Product Change Notification

PCN Number:	RLPCN251802
Product Category:	Electromechanical Power relays
Subject:	Maximum dimensions change
Product series:	FTR-LY series
Date:	01 May, 2025

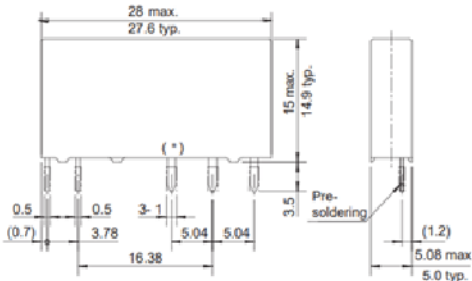
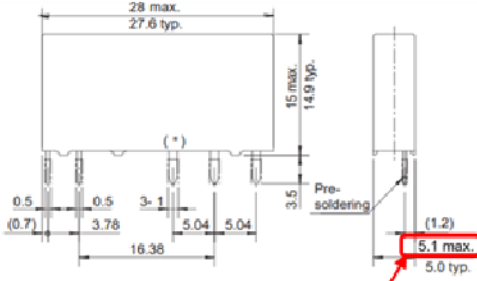
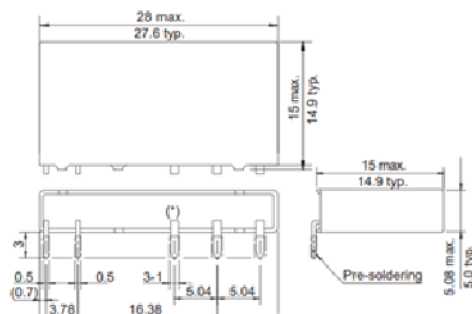
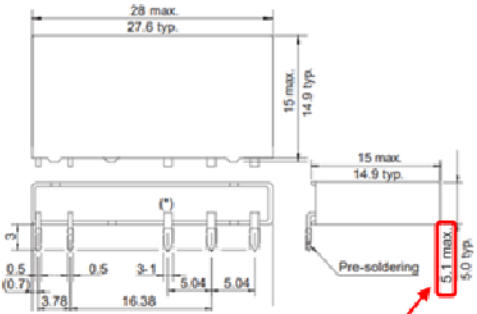
Maximum dimensions of FTR-LY Relay will change.

Current	After changed
Dimensions Straight type Ex. Transfer Relay	 Max.dimensions(mm) : 28×15×5.08	 Max.dimensions(mm) : 28×15×5.1
Dimensions Right angle Ex. Transfer Relay	 Max.dimensions(mm) : 28×15×5.08	 Max.dimensions(mm) : 28×15×5.1

※This change gives no impact on Relay's characteristics.

For purpose of stable molding.
